Review of Dust Deposition and Suppression Impacts on Tiehm's Buckwheat from the Rhyolite Ridge Lithium-Boron Project

Technical Memorandum prepared for Center for Biological Diversity

May 31, 2024

Figure 5b - Threatened and Endangered Species SER (2024) Silt Content in Critical Habitat Occupied and Unoccupied areas.

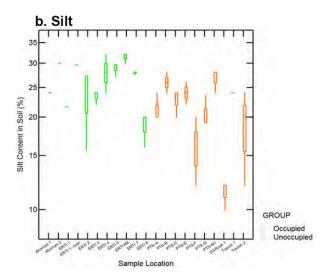
As discussed in the previous section, silt fraction values for the haul road ranged from 1.7% to 6.4% which is at least a factor of 3 lower than observed silt values within the critical habitat (~12% to ~32%, with an average silt content of 25.7%) (Threatened and Endangered Species SER, 2024 – see Figure 5b below), and a factor of 2 lower than the content of the ore stockpile in Table 13 of Appendix B (AQIA 2023, v5.6). Silt content is a key factor in dust deposition. Moreover, the silt fraction of 6.4% requires routine gravel application which has not been described as part of the DEIS or mitigation measures for dust suppression.

Figure 1. Tonopah Airport Wind Rose from Iowa Environmental Mesonet ASOS network¹ – based on hourly wind observations from 1970 through 2024.

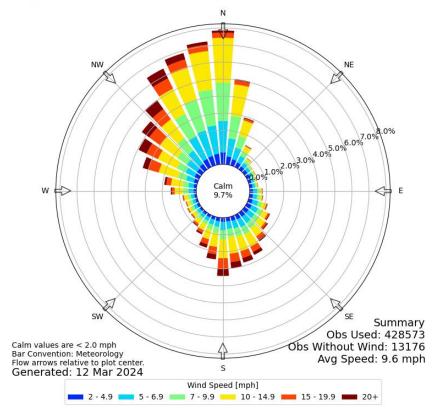
The Tonopah Airport Wind Rose is shown in **Figure 1.** Winds are predominantly on a north-south axis, originating from the north most of the time. Winds from the northwest are slightly higher wind speeds. This wind rose is extremely unlikely to represent the winds at Rhyolite Ridge along the haul road, which is in a canyon at approximately with ridges rising well over 1,000 feet above the canyon floor to the north and south of Cave Springs Rd.

In an area with multiple high ridges, it is likely that the topography channels the wind along Cave Springs Rd on a path of least resistance through the mountainous terrain. Therefore, it is unlikely that the Tonopah airport meteorology will be the same directionally (due to mountainous terrain to the north of the project area).
